AGNICO EAGLE

Re: Response to Comments Sump 4 and Sump 5 Design Reports for the Hope Bay Type A Water Licence No. 2AM-DOH1335

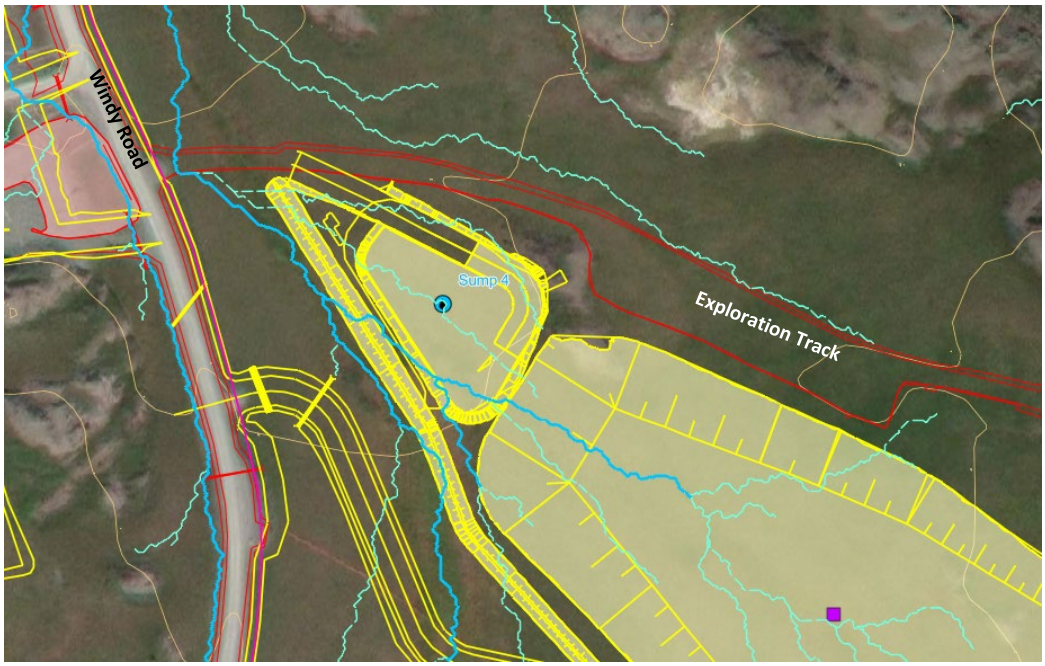
Request Made by Interested Party:
CIRNAC recommends that the Proponent provide additional information on the proximity of Sump 4, the access road, and diversion berm(s) relative to the adjacent stream, and ensure all monitoring and mitigation measures be implemented during construction to minimize the potential for sedimentation, erosion, or dust deposition to nearby freshwater environments and align with all relevant Water Licence requirements.

Agnico Eagle's Response to Request:
The figure below shows the main drainage path in the area where Sump 4 and the overburden area will be built. Currently, the runoff naturally drains to the corner of the existing exploration track and Windy Road and continues its path toward Patch Lake.

Sump 4 is excavated downstream of the planned overburden pile; therefore, all runoff from the overburden pile will flow via gravity into the sump. The main purpose of the diversion berm is to divert clean runoff away from Sump 4 so that only contact water from the overburden pile is managed.

Erosion and sediment control measures will be in place during construction (i.e., silt fence) to mitigate any erosion and sediments from entering the stream.
